## **AMENDMENTS TO THE DRAWINGS**

#### **REMARKS**

Application No. 09/892,769 Amendment dated July 14, 2009 After Final Office Action of May 5, 2009 Docket No.: 3562-0118P

FIG. 1

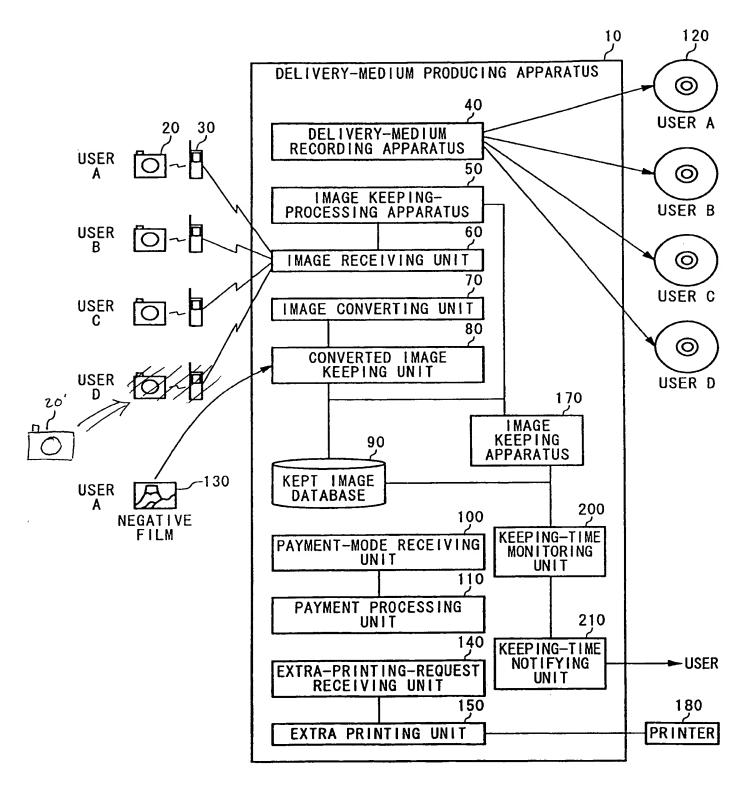
The Examiner objected to the drawings for failing to show various claimed elements. Particularly, the Examiner points out that the drawings do not show (1) the digital camera which directly communicates with the delivery-medium producing apparatus, and (2) the controller for controlling the capturing device and wireless communications being an integral component of the camera.

The attached sheets of drawings include changes to Fig. 1. The changes to Fig. 1 are illustrated by the annotations in the attached Annotated Sheet. It is respectfully submitted that neither the changes to Fig. 1 adds any new matter to the application.

Attached hereto is a corrected drawing to Fig. 1 illustrating a digital camera 20' into which the mobile phone functionality is integrally formed therein. Applicants respectfully submit that such correction to Fig. 1 does not add new matter to the present application. This correction is supported, e.g., in page 22, line 34 – page 23, line 2. As such, corrected Fig. 1 now clearly illustrates a digital camera 20' with wireless communication functionality built therein. Accordingly, it is clear from corrected Fig. 1 that the internal controller of digital camera 20' would control both the camera functionality as well as the wireless communication functionality.
